E0000498 and E0001526B Sensors

Information on the use of Balluff retroreflective measure sensors

Compatibility

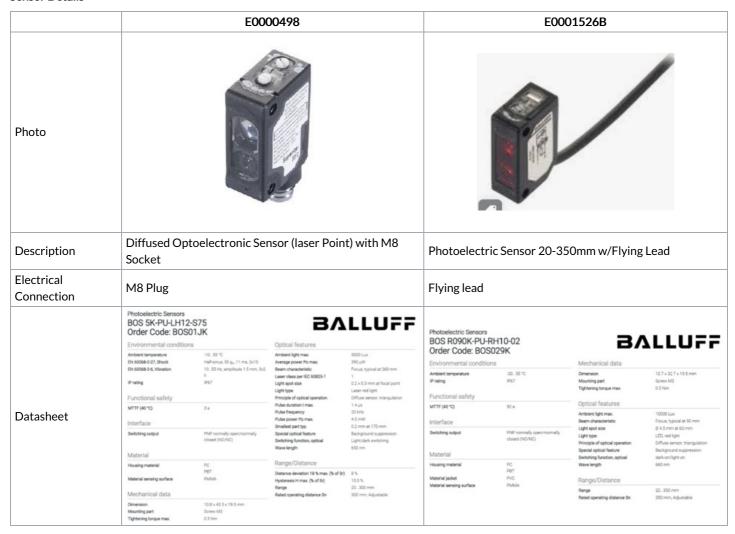
During the supply chain shortages of 2021-2023, E0000498 was not available, and E0001526 was supplied instead (BOS0129). This part also became difficult to get, so E0001526B was source instead.

- Parts are Mechanically compatible
- E0001526 comes with a flying lead, so needs a plug or socket on the end. To replace an E0000498, add a Exxxxxx plug connector with a short (10cm) tail.

E0001526B have proven to be a better sensor for detecting **dark and rosewood profile**. The only downside is the difference in electrical connection
